Seismic Walkdown Checklist (SWC) SWEL1-058

Equipment ID No. SI MVA602-B

Equipment Description SAFETY INJECTION SUMP OUTLET HEADER B ISOLATION

Equipment Description Control Room Air Handling Unit AH-12A

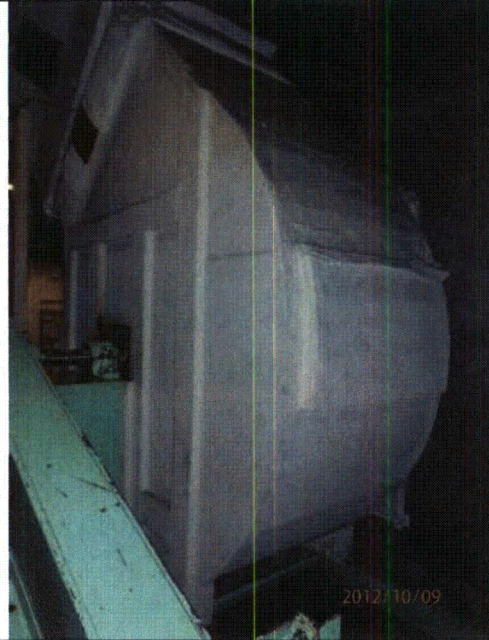
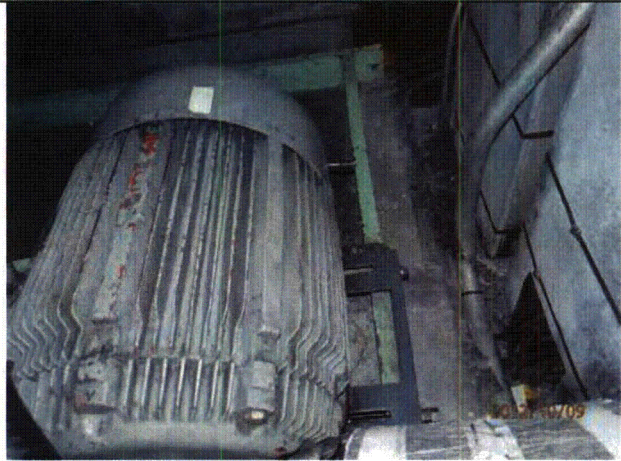
Note: Mild surface corrosion on shaft housing bolt

Equipment Description Control Room Emergency Filtration Unit B

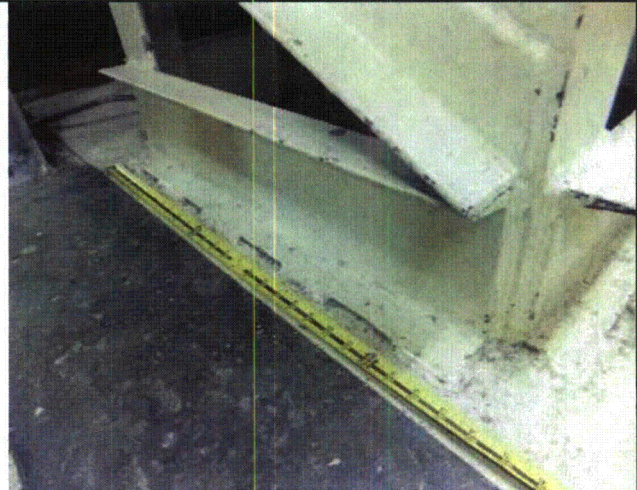
Note: Weld configuration on base frame

Equipment Description PDP MD NUCLEAR INST CHANNEL D

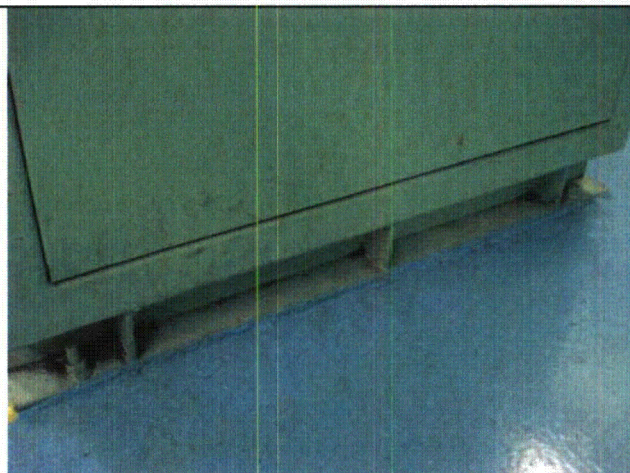
Note: The panel is identified based on all breaker IDs of B289-S146.

Note: Anchorage configuration consistent with IPEEE of the identical item ID EPDPMA (PDP-3MAS)

Equipment Description NITROGEN HEADER 6 PRESS INDICATING SWITCH

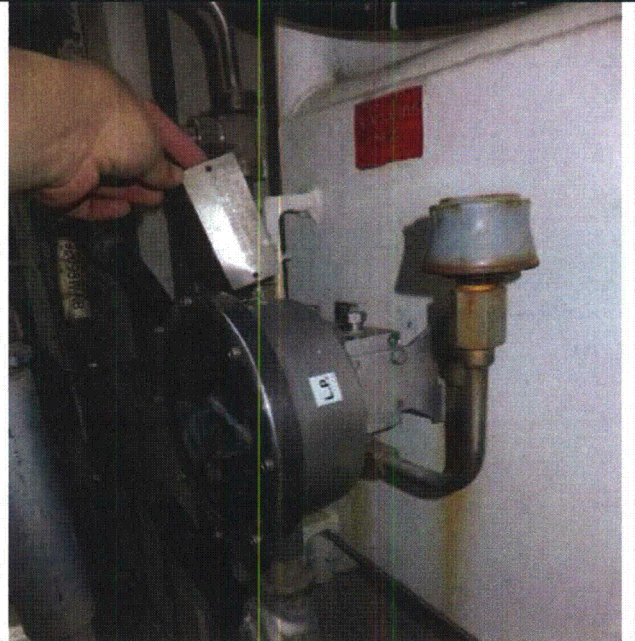
Note: Switch anchorage to support has mild corrosion

Equipment Description Core Protection Calculators

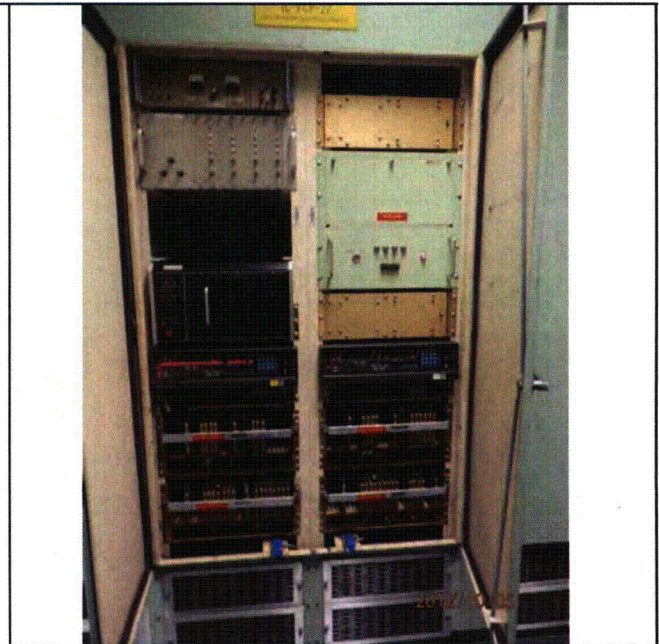
Note: Example of one of the four cabinets on ECP-22. A picture of the anchorage could not be made in order to not break the plane of the door, but it was determined to be in good condition. Notice the four unistruts. All are in good condition and bolted properly.

Note: Example of the front of ECP-22. All internals are well supported. Anchorage is not visible from this side.

Equipment Description Process Analog Control Protective Channel B

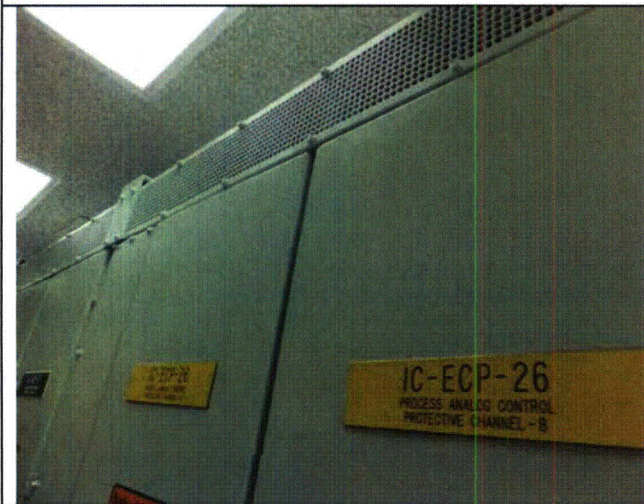
Note: Cabinets are now bolted together

Seismic Walkdown Checklist (SWC) SWEL2-004

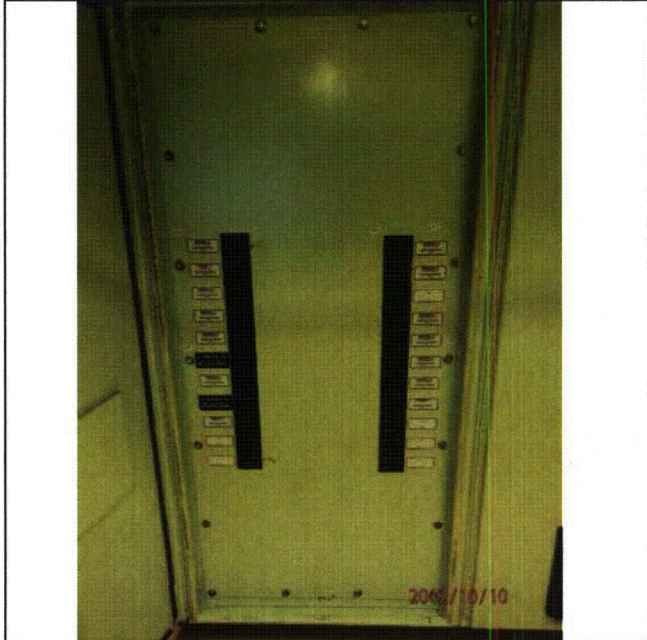
Note: This surface crack leads to an anchor bolt, but it is not a seismic or structural concern (same on other side)

Equipment Description Component Cooling Water Pump A

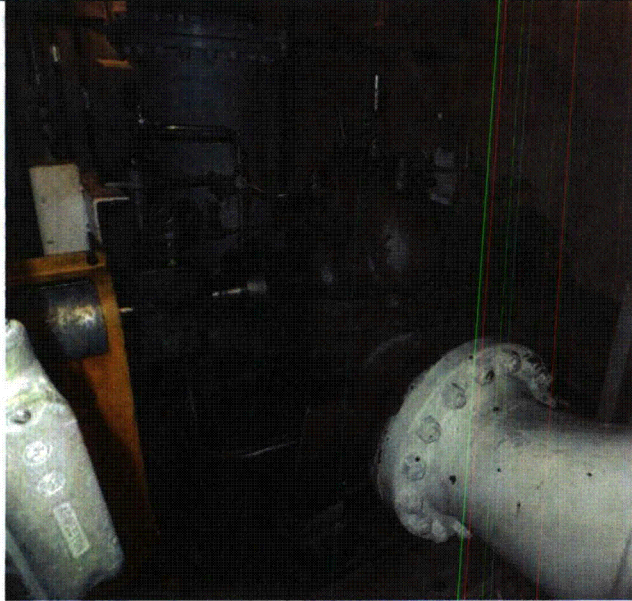
Note: Leakage and mild corrosion around base of pump

Note: Leakage and mild corrosion around base of pump

Note: Fuel Pool Pump B

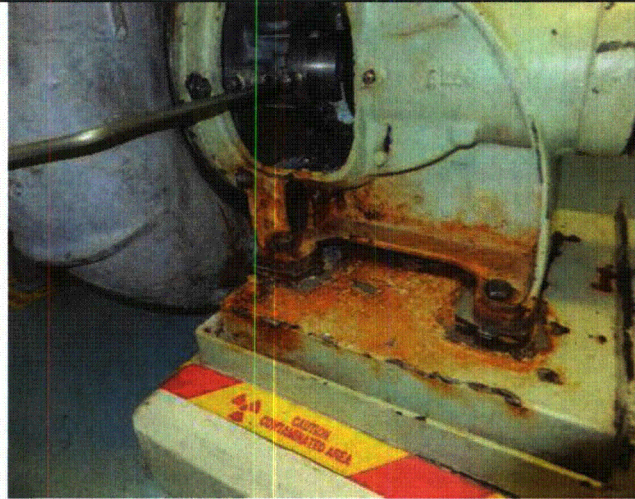
Note: Mild corrosion on pump
